Access Compliance Report

Public Rights-of-Way

(Curb Ramps)

Intersection ID: 10021176	Main Street: BILLINGSLEY_RD	Cross Street: N/A	Location: SW
ADA ID: 73EB6BADA7C8	Ramp Type: PerpDiag	Initial Pass/Fail: Fail	Overall Compliance: No
		Severity Score: 12.5

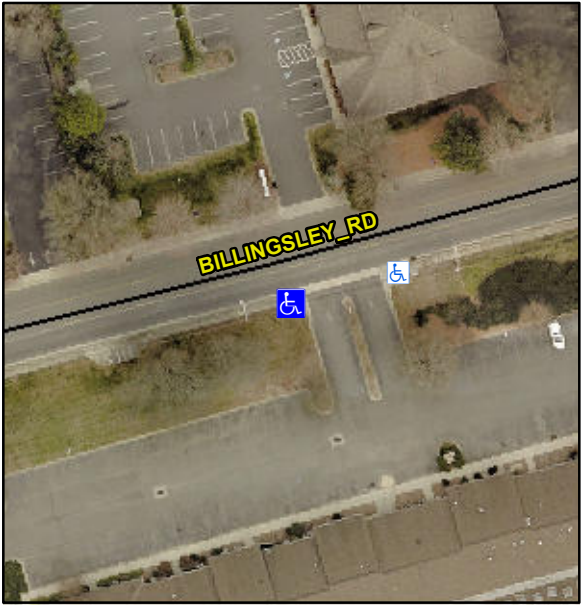
Codes/Mitigation Info/Possible Solution		Field Measurements/Component Compliance					
	Possible Solutions:						
	Remove & Replace Curb Ramp With Two New Directional Ramps or Equivalent.	N/A	Ramp Length (in)	49.0	No	Ramp Slope (%)	8.8
		Yes	Ramp Width (in)	48.0	Yes	Ramp XSlope (%)	1.7
		N/A	Flare Type LT	N/A	N/A	Flare Type RT	N/A
		N/A	Flare Slope LT (%)	N/A	N/A	Flare Slope RT (%)	N/A
		N/A	Flare Traversable LT?	N/A	N/A	Flare Traversable RT?	N/A
		N/A	Landing Length (in)	N/A	N/A	DWS Provided?	N/A
		N/A	Landing Width (in)	N/A	N/A	DWS Contrast?	N/A
		N/A	Landing Slope (%)	N/A	N/A	DWS Length (in)	N/A
		N/A	Landing X Slope (%)	N/A	N/A	DWS Full Width?	N/A
		N/A	Landing Curb? (Y/N)	N/A	N/A	DWS Offset (in)	N/A
		N/A	Shared Landing?	N/A			
		N/A	Gutter Ponding?	N/A	N/A	Gutter Slope (%)	N/A
		N/A	Gutter Lip Ht (in)	N/A	N/A	Gutter X Slope (%)	N/A
		N/A	Painted X Walk1?	No	N/A	Painted X Walk2?	No
			X Walk 1 Direction	To E		X Walk 2 Direction	To N

N/A	X Walk 1 Width (in)	N/A	N/A	X Walk 2 Width (in)	N/A
			X Walk 1 Slope (%)	4.2		X Walk 2 Slope (%)	2.7
			X Walk 1 X Slope (%)	3.3		X Walk 2 X Slope (%)	5.8
		N/A	Ramp inside XWalk1?	N/A	N/A	Ramp inside XWalk2?	N/A
<p>Surveyor Notes:</p> <p>N/A</p>			Road Slope (%)	1.5	N/A	Clear Space?	N/A
			Road X Slope (%)	8.2	N/A	Clear Space to XWalk (in)	N/A
<p>PROW/ADA:</p> <p>Not Found, R304.2.2</p>		N/A	Any Obstructions?	N/A	N/A	Storm Grate/Utility Hazard?	N/A
			Obstruction Type			Storm Grate/Utility Type	
Total Cost:		\$	3200.00		N/A		N/A
					Yes	Surface Condition? (G/P)	Good
